# TSI revision 2022

## Digital Rail and Green Freight

### Annex 2- TSI ENE

Based on the Commission Regulation (EU) No 1301/2014

~~The half length  $b_w$  of the pantograph bow depends on the type of pantograph used. The pantograph profile(s) to be considered are defined in LOC&PAS TSI, point [clause 4.2.8.2.9.2](#).~~

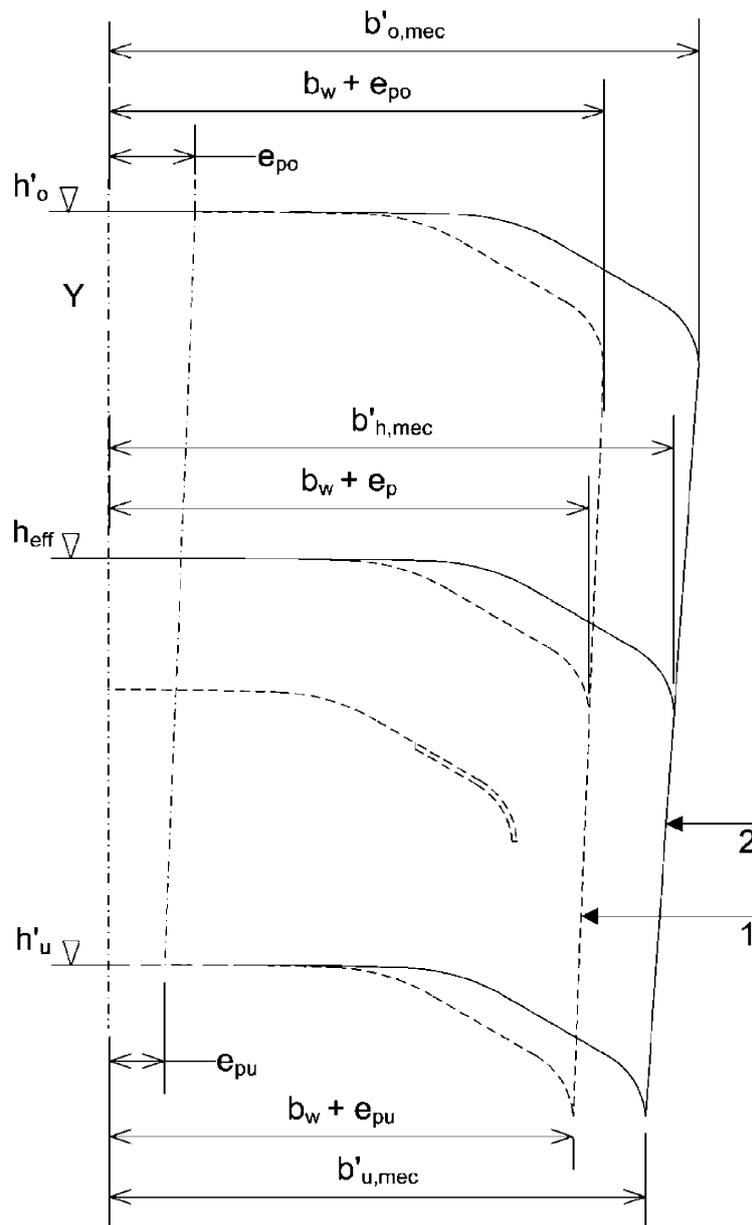
~~D.1.2.1.3 — Half length  $b_w$  of the pantograph bow~~

Figure D.31

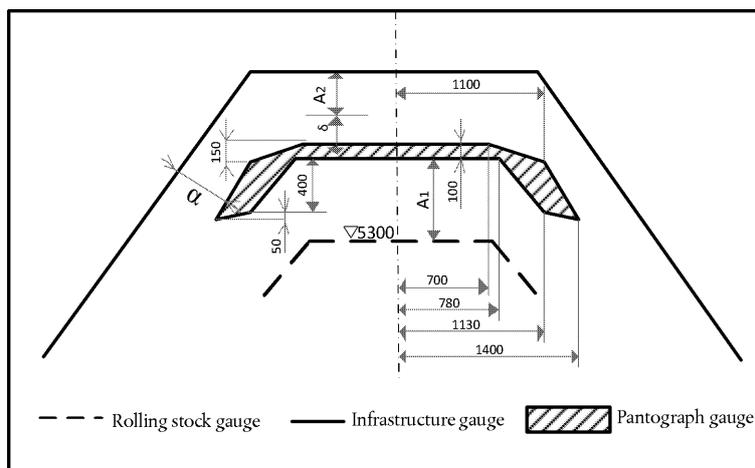
The pantograph gauge shall conform to Figure D.3 and Table D.1.
